Project	<b>IEEE 802.16 Broadband Wireless Access Working Group</b> < <a href="http://ieee802.org/16">http://ieee802.org/16</a> >	
Title	<b>RS Uplink HARQ on Dedicated Channel</b>	
Date Submitted	<b>2007-07-05</b>	
Source(s)	Derek Yu, Hang Zhang, Peiyong Zhu, Wen Tong, David Steer, Gamini Senarath, Mark Naden, G.Q. Wang Nortel 3500 Carling Avenue Ottawa, Ontario K2H 8E9	Voice: +1 613 763-1315 E-mail: <a href="mailto:wentong@nortel.com">[mailto:wentong@nortel.com]</a> <a href="mailto:pyzhu@nortel.com">[mailto:pyzhu@nortel.com]</a>
Re:	This document is in response to call for technical comments and contributions IEEE 802.16j-07/019 dated 2007-06-07.	
Abstract	The current UL HARQ support defined in the current baseline is for centralized control. It involves substantial efforts to identify failure link and perform subsequent retransmission allocation. Whenever a failure occurs, all resources allocated beyond the failure link are wasted as well. As UL dedicated channel is a persistence allocation, there is no need for the MR-BS to reschedule retransmission. Hence, there is no needed to identify the failure link as well. This contribution proposes the required mechanism to enable HARQ co

Figure XXX – UL DCH control header

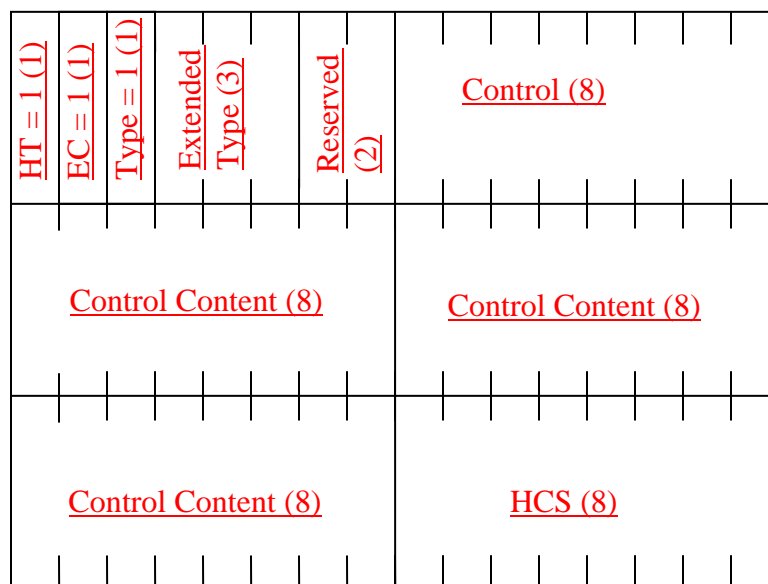
#### 6.3.2.1.2.2.2.5 UL DCH control header

The UL DCH control header is used by the RS to send control signaling to MR-BS or parent RS. The header format is as follows:

<u>Syntax</u>	<u>Size</u>	<u>Notes</u>
<u>MAC Header()</u>		
<u>HT</u>	<u>1 bit</u>	<u>Shall be set to 1</u>
<u>EC</u>	<u>1 bit</u>	<u>Shall be set to 1</u>
<u>Type</u>	<u>1 bit</u>	<u>Shall be set to 1</u>
<u>Extended TYPE</u>	<u>3 bits</u>	<u>Shall be set to 0100 for UL DCH control header</u>
<u>Reserved</u>	<u>2 bits</u>	
<u>Control</u>	<u>8 bits</u>	<u>Bit #0, if set to 1: HARQ control signaling</u>
<u>Control Content</u>	<u>24 bits</u>	<u>If Bit #0 of Control field is set to 1 { The control content is sub-divided into 6 groups of 4 bits which allow up to 6 UL DCH regions for HARQ burst transmission. The first group of 4 bits</u>

<u>corresponding to the first allocated DCH region and so on. The first bit of the 4 bits when set to 1 indicate HARQ enabled. The next 2 bits indicate ACID within the specific region. The last bit indicate AI SN.</u>
<u>HCS</u>	<u>8 bits</u>	<u>Header check sequence</u>
<u>1</u>

Figure XXX. Format of DL MAC control header.

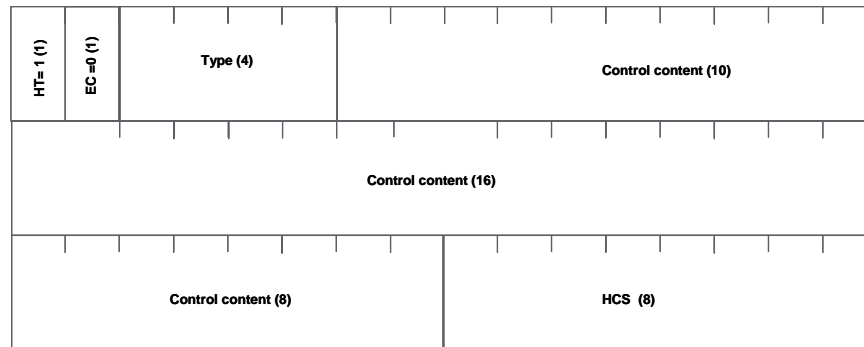
6.3.2.1.3 DL MAC Header without payload (DL MAC control header)

This DL MAC header without payload (control MAC header) is sent on DL only. The DL MAC control header is used for MR-BS or RS(s) to send control signaling to its child RS(s). The format of DL control MAC header is shown in Figure XXX.

<u>Name</u>	<u>Length (bits)</u>	<u>Description</u>
<u>HT</u>	<u>1</u>	<u>Header type. Should be set to 1</u>
<u>EC</u>	<u>1</u>	<u>Encryption control. Shall be set to 0</u>
<u>Type</u>	<u>4</u>	<u>Type of control</u> <u>Bit #0, if set to 1: HARQ ACK/NACK Bitmap</u>
<u>Control content</u>	<u>34</u>	<u>If Bit #0 of Type field is set to 1{</u> <u>The first 6 bits of control content form the</u> <u>corresponding HARQ ACK/NACK bitmap for the UL</u> <u>HARQ bursts specified by the UL DCH control header.</u> <u>}</u>
<u>HCS</u>	<u>8</u>	<u>Header check sequence</u>
